Staff Report to the Technical Review Committee August 5, 2014

TOUFAYON BAKERY REPLAT 3826 BRYN MAWR

The applicant proposes to replat two parcels to include portions of the Toufayan Baker additions that cross the property line, per an agreement made with the City.

PROPOSED PLAT

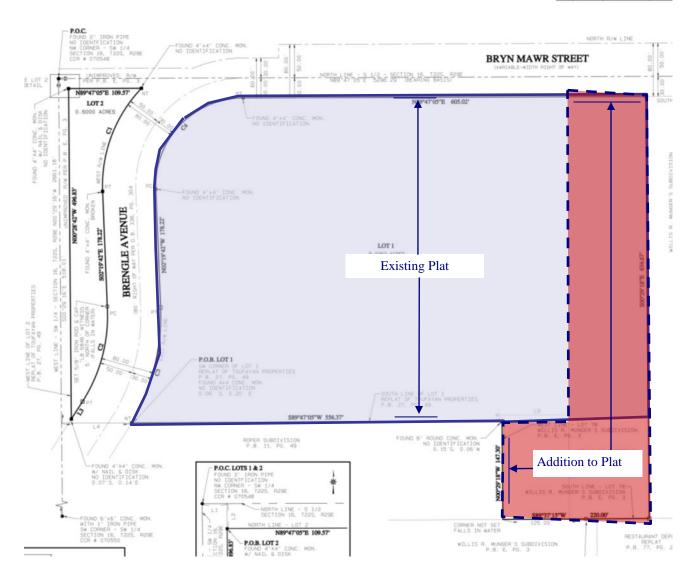
1. Any/all areas to be dedicated to the public must appear in the dedication. If none, it should be so indicated in the dedication. example "...dedicates nothing to the public."

- 6. Plat Face Changes There are a number of changes required to the face of the plat. In addition to the changes required on the plat, the following is a list of additional requirements. 1) Changes to the face of the plat. (A copy has already been returned to the surveyor). 2) Recording Fees (Checks should be made payable Orange County Comptroller.) 3) The plat must be reviewed by Orange County prior to recording. Begin this process by taking a copy of the executed plat to Room 1700 (Orange County Property Appraiser's Office, Attn. Rocco Campanale), 200 S. Orange Avenue, Sun Trust Bank Center. The original completed Statement of Lien from Orange County is required by this office. The Statement of Lien must be received by this office prior to recording the plat.
